CITY OF MILWAUKIE PLANNING COMMISSION MINUTES TUESDAY, JULY 26, 2005

Vice-chair Carter opened the hearing on Community Service Overlay CSO-05-01 a minor quasi-judicial hearing to consider approval of allowing a 4-lot re-plat, a street construction variance and a street vacation. The criteria to be addressed can be found in the Milwaukie Zoning Ordinance Section 19.303 - Residential R-5 Zone; 19.322 - Water Quality Resource Regulations; 19.700 - Variance Exceptions and Home Improvement Exceptions; 19.1011.3 - Minor Quasi Judicial Review; 19.1400, - Transportation Planning Design Standards and Procedures; as well as the Land Division Ordinance Title 17; and Oregon Revised Statute ORS 271.

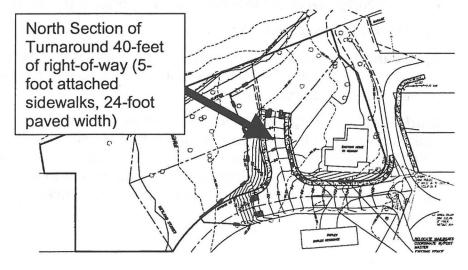
Given these limitation, staff agrees with applicant that building full-street improvements is not feasible or practical. However, staff believes that some improvements must be installed since the existing improvements are not adequate. To mitigate for not installing curb and sidewalk on 28th Avenue, the applicant has proposed sidewalk on the east side of the road. However, part of the sidewalk crosses private property and an easement has not been obtained. Staff believes that sidewalk would work best on the west (applicant's) side of the road. Staff recommends the following improvements:

- 5-foot concrete sidewalk and curb from Rockvorst Avenue to Sherrett Street.
- 18-feet of pavement width (current width is 10 feet).
- A retaining wall that would be needed approximately 5 feet tall.
- Guardrail at the edge of the sidewalk to prevent vehicles from driving over the edge.
- Fence that is located in the right-of-way removed.
- (2) Waive requirements to build street on undeveloped Rockvorst Avenue and Depot Street.

c. Half Street Improvements

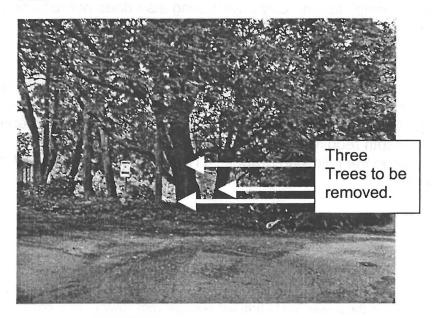
The applicant is proposing to install partial street improvements on Rockvorst Avenue. Half-street improvements with a minimum of 20 feet of pavement may be approved when the opposite side of the street has the potential to redevelop.⁶ This ensures that the other side of the street will be built with future development.

Applicant Justification: The applicant proposes a half street with 28 feet of pavement width and sidewalk on the development (north) side. The applicant claims that the south side of the street has redevelopment potential that will allow the sidewalk on the south side to be completed in the future

6. Sewer Pumps

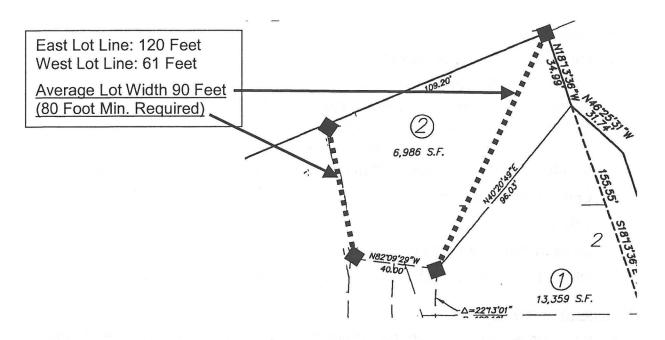
Each house will have its own private sewer pump since the property is downhill from the gravity sewer main. The Building Official requires that the pumps be designed by an engineer to ensure that they will operate correctly. The pumps will have a reservoir and backflow prevention device⁷ installed. This will allow the sewer to work for a few days in the event the power goes out. An alternative to a private system would be to install a public pump station. City engineering staff does not recommend a public system due to maintenance cost to the City.

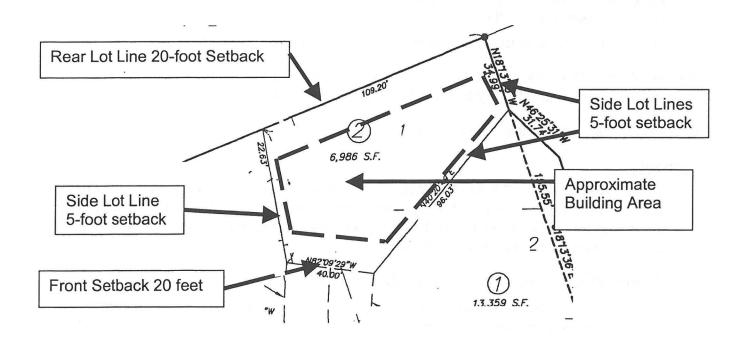
Interpretation is also needed for building setbacks for Lot 2. The front, side and rear lot lines must be determined in order to determine setbacks. Staff recommends the Planning Commission interpret front, side and rear property lines as shown in the following graphic.
